WILLIAMSON COUNTY, TEXAS

CHANGE ORDER NUMBER: 2

Project: 22IFB39

Roadway: CR 111

SHEET 1 OF 6				SCALE: 1"=100'H 1"= 10'V	
DATE: 3/24/2022		DN:	DW:	CK:	AP:
FED. RD. DIV. NO. 6		FEDERAL AID PROJECT NO. ----			SHEET NO. 149
STATE		DIST.	COUNTY		
TEXAS		---	WILLIAMSON		
CONT.		SECT.	JOB	HIGHWAY NO.	
----		--	---	CR 111

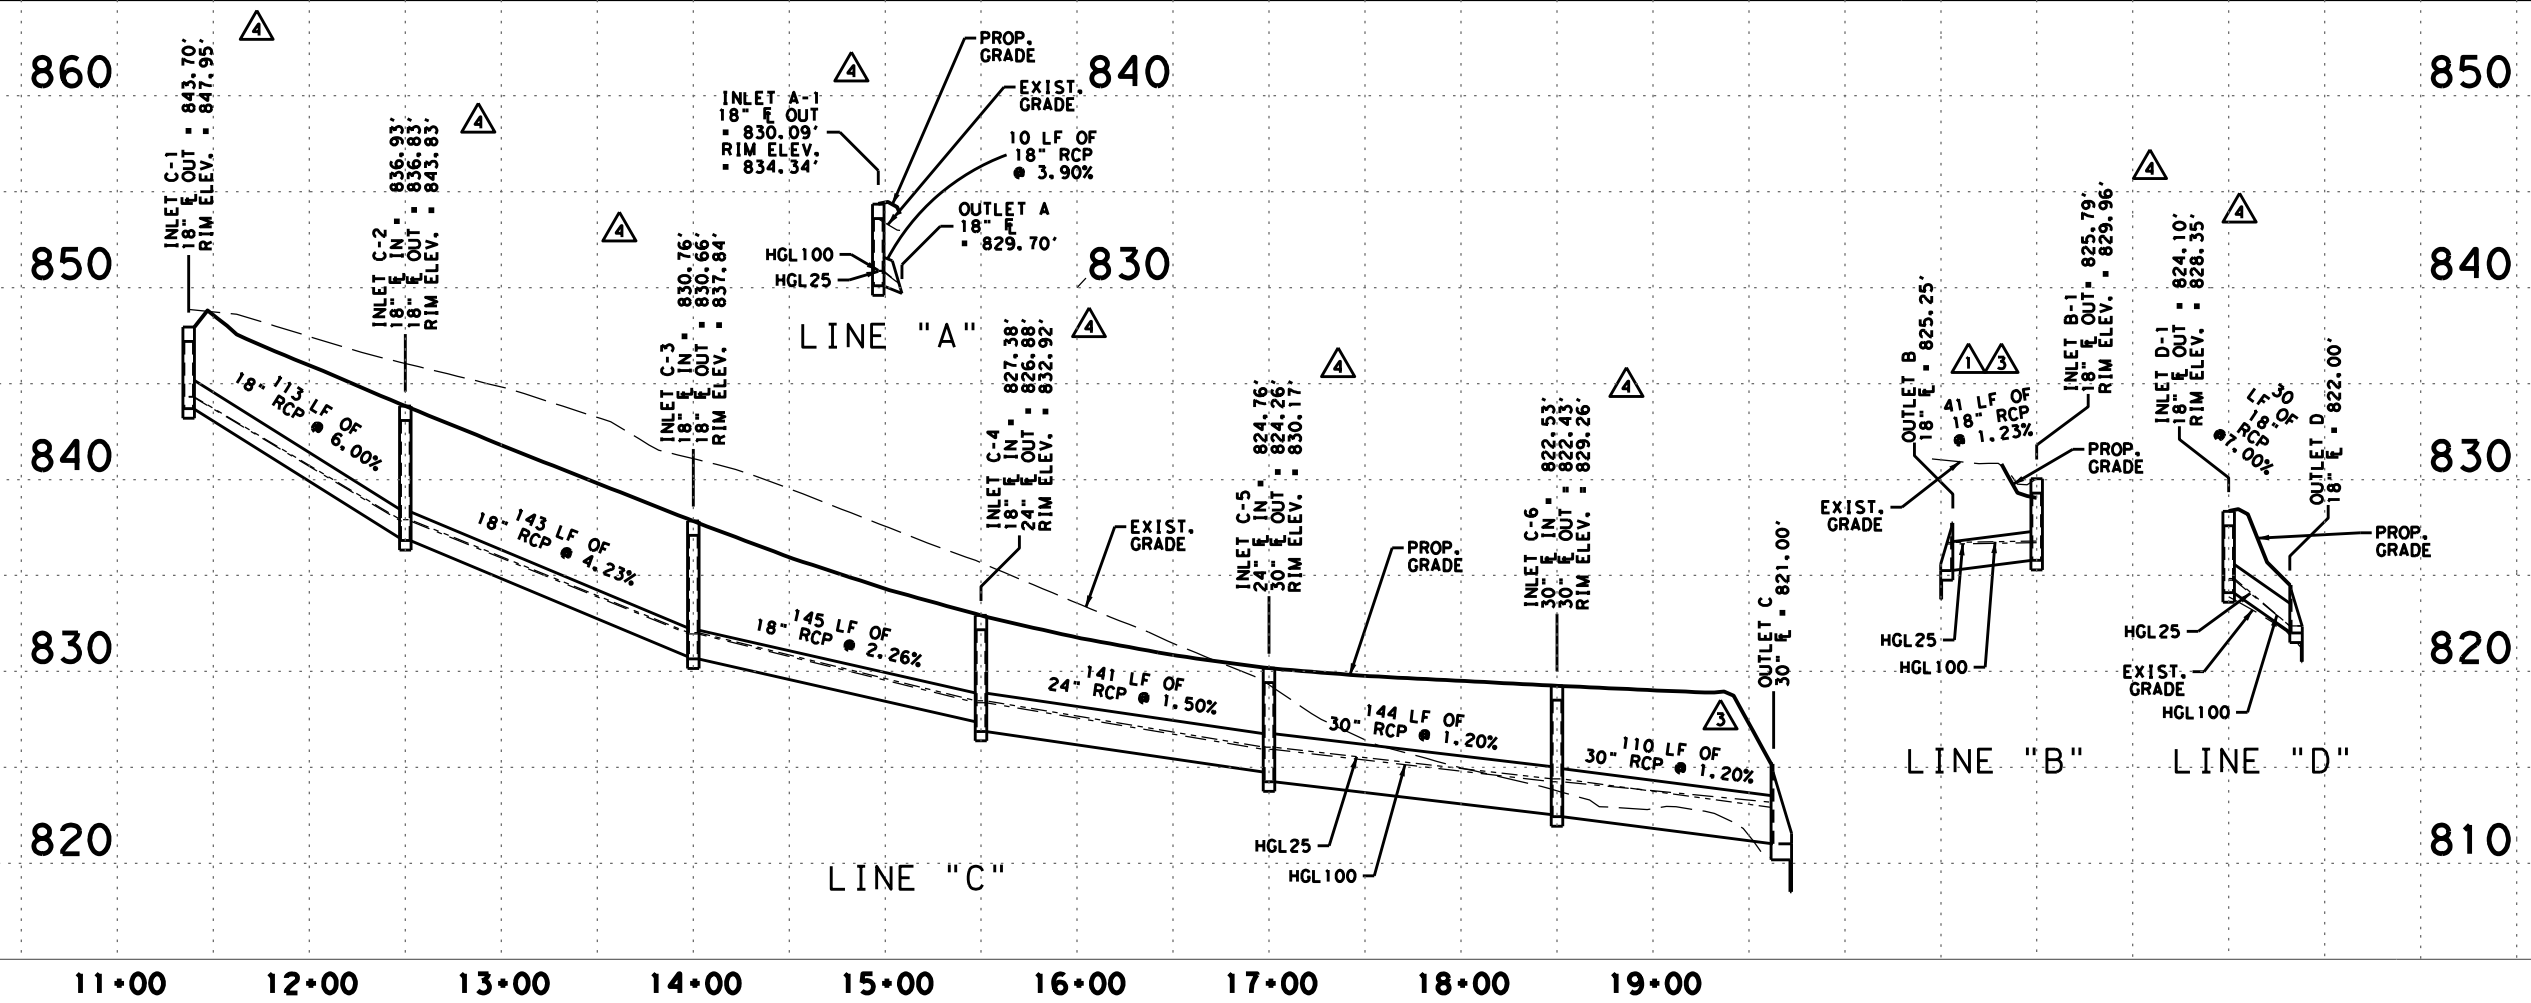
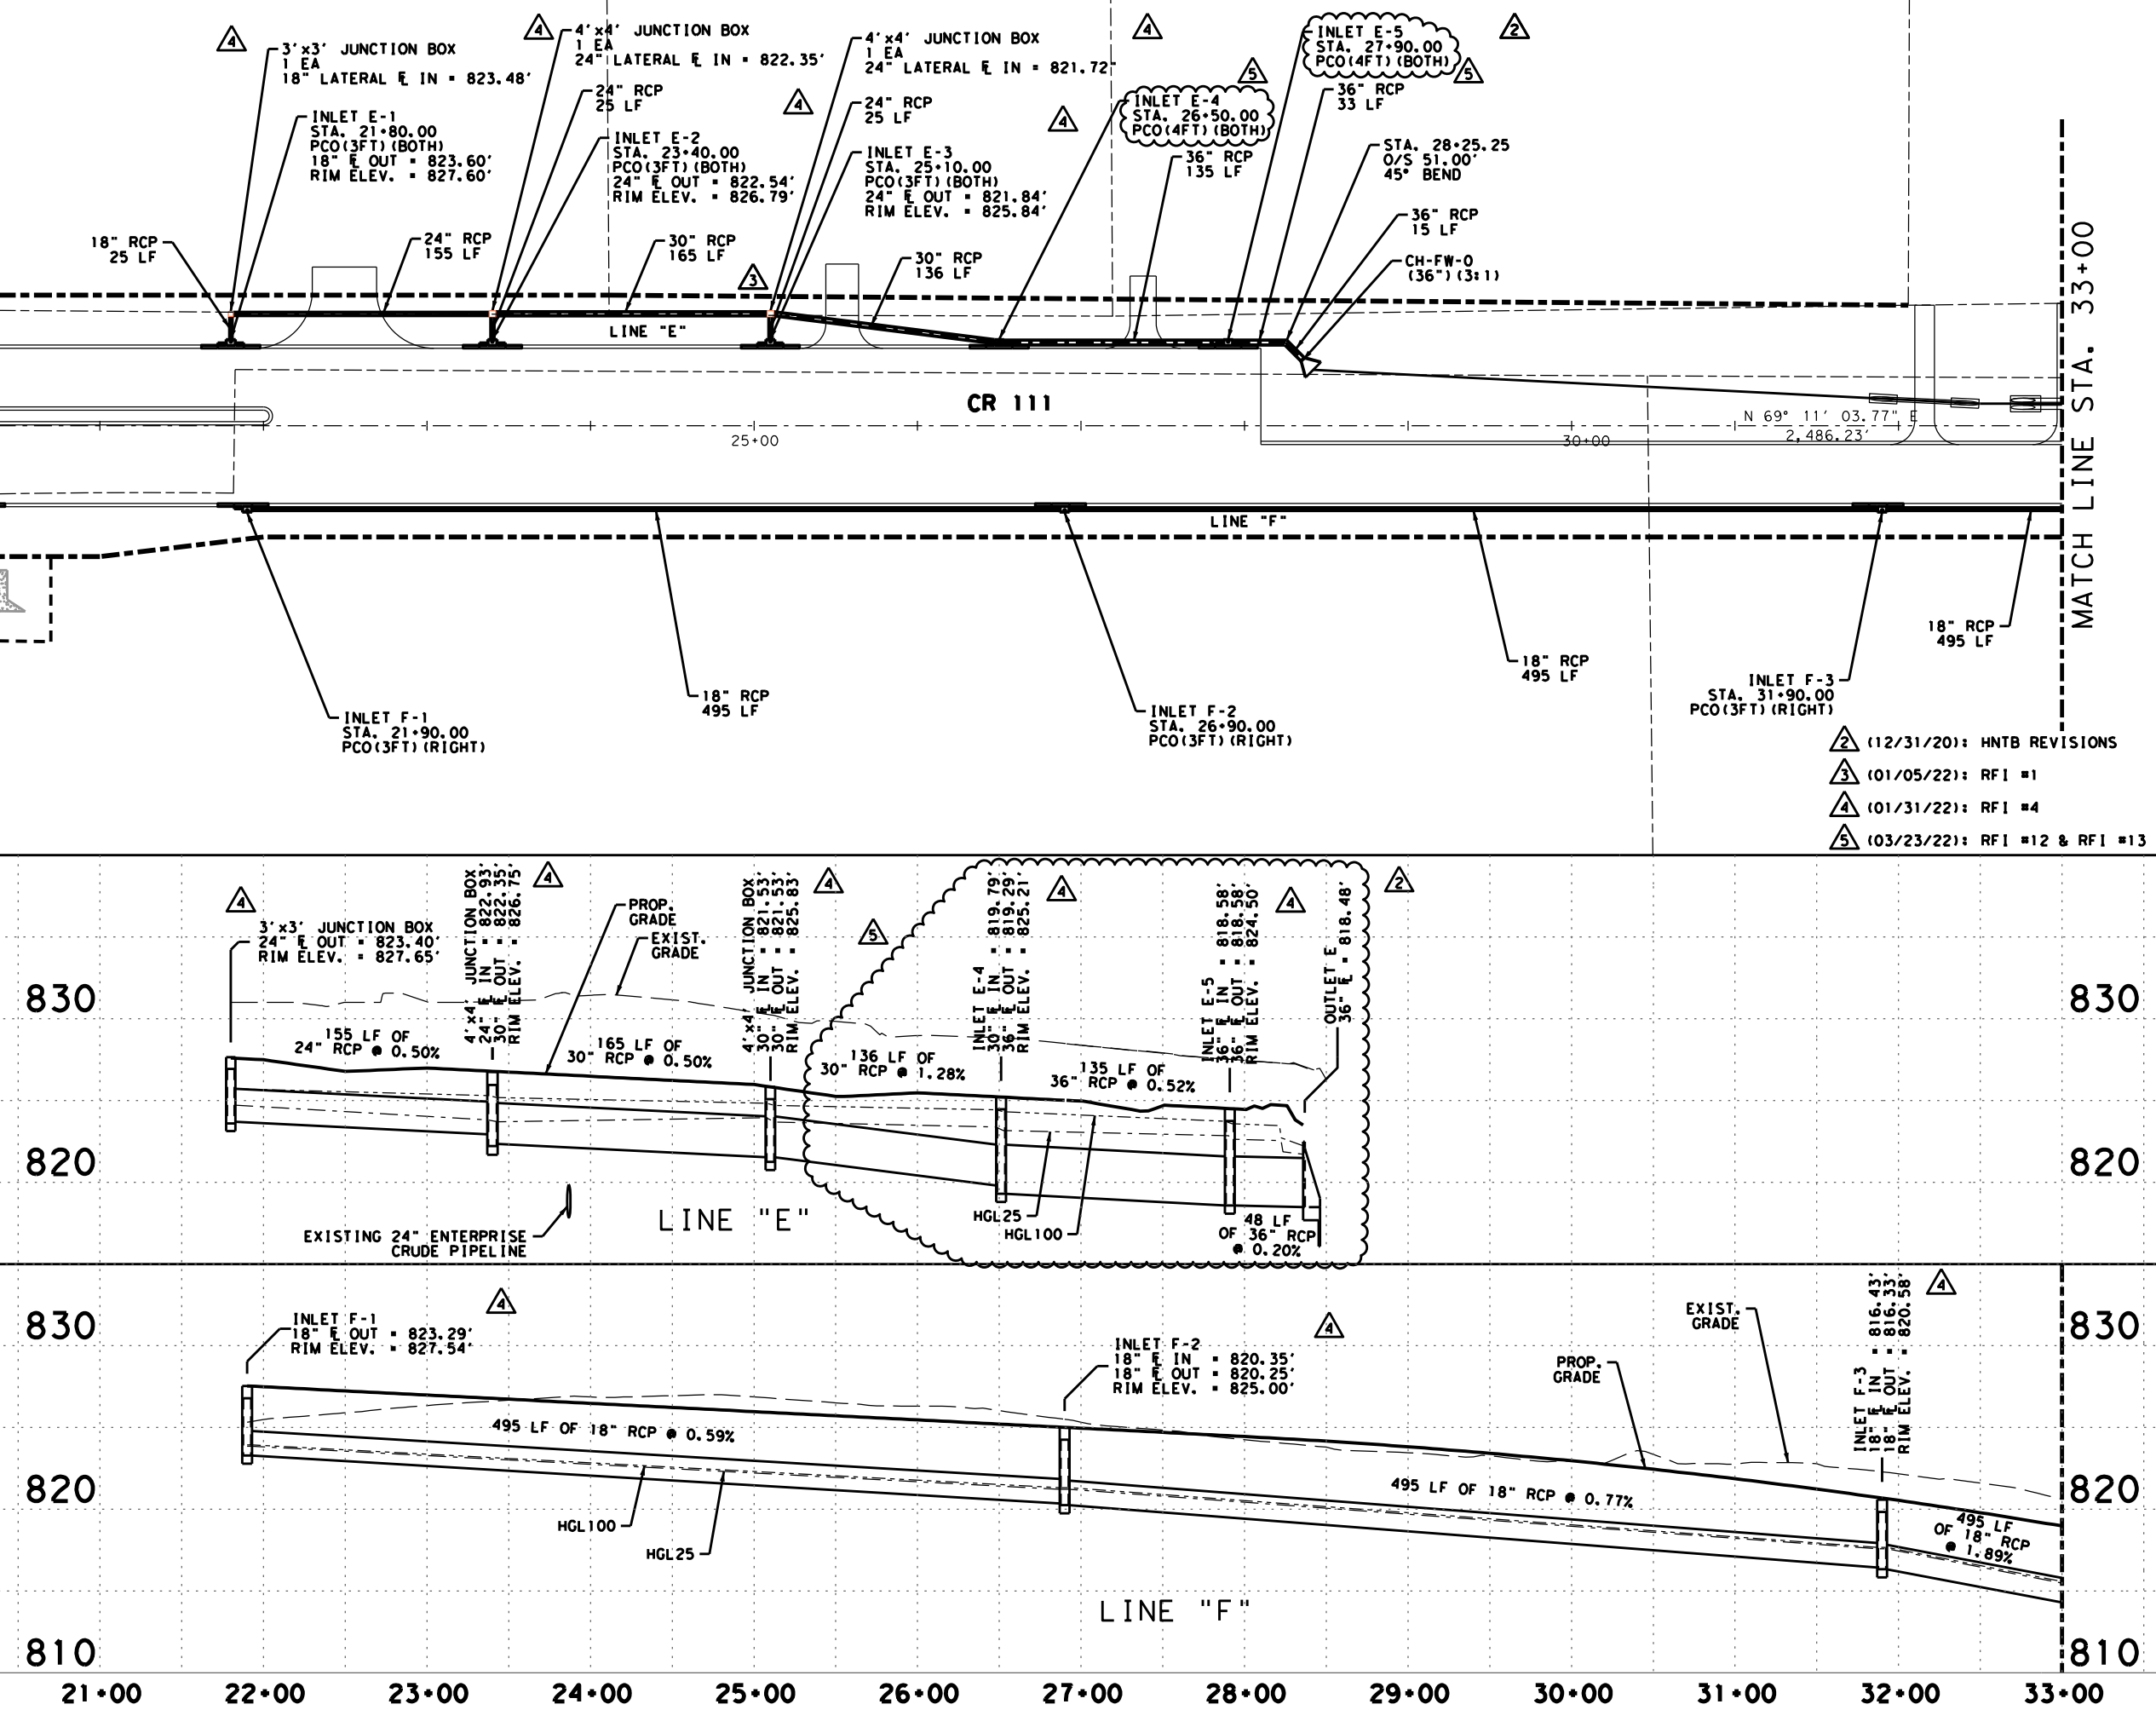
1B. Design Error or Omission. Other: This change order compensates the Contractor for upsize changes in 6 inlet and 1 junction box to accommodate pipe size design. The revisions affected estimate page 15, summary page 18, storm drainage pages; 149 for Inlet C-5 and C-6, page 150 for Inlets E-4 and E-5, page 151 for Inlet F-6, page 153 for Inlet I-6 and page 154 for Junction Box K.

Scope: 1. Inlets C-5, C-6, E-4, E-5, F-6, and I-6 upsized to 4' x 5' to accommodate pipe sizes.
2. JB-K upsized to 5' x 5' to accommodate pipe sizes
